ADDENDUM NUMBER: One (1)

TITLE: Three-Phase (Small and Large), Single-Phase Pad Mounted, Pole Mounted and Miscellaneous Transformers for JEA Inventory FY26

JEA SOLICITATION NUMBER: 1412071247

XIV. DIMENSIONAL REQUIREMENTS

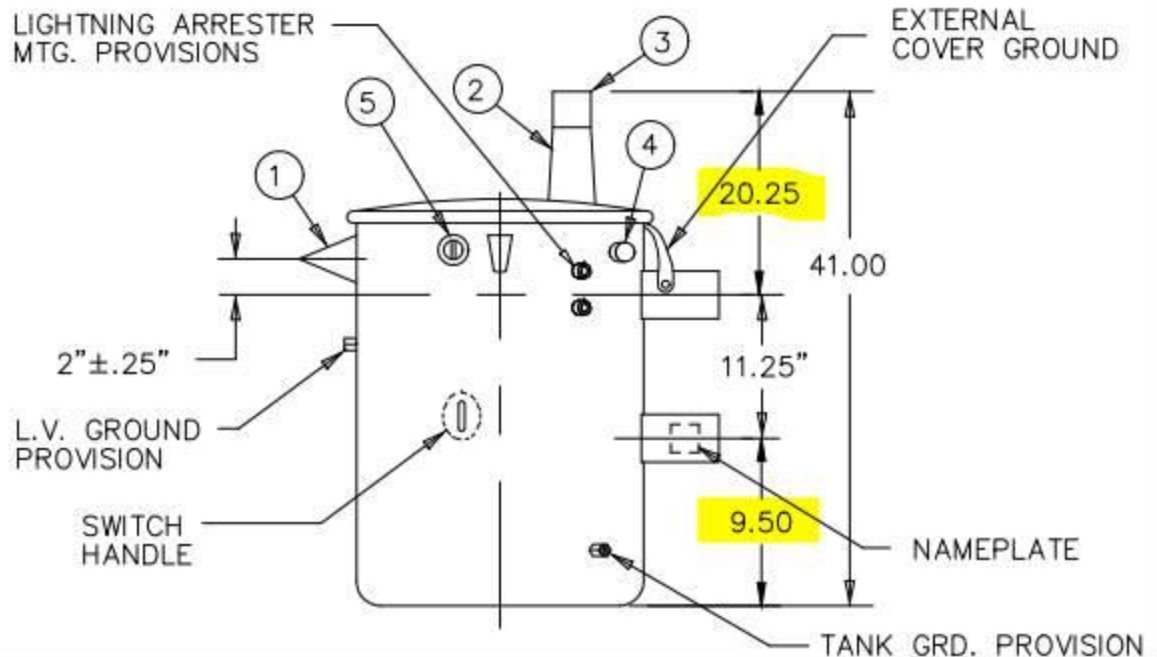
2. **Question:** Can JEA confirm what exactly they are referring to when they reference the “top mounting hole” and “bottom mounting hole” in the below spec? Also, can you verify that the max diameter is just for the tank itself or does this include any components that extend off the tank? Do they have a max width and depth for these or is it just a max on the diameter?

Answer: Standards needs to know the distance from the mounting hole in the top bracket to the top of the bushing and the distance from the mounting hole in the bottom bracket to the bottom of the transformer. See example below.
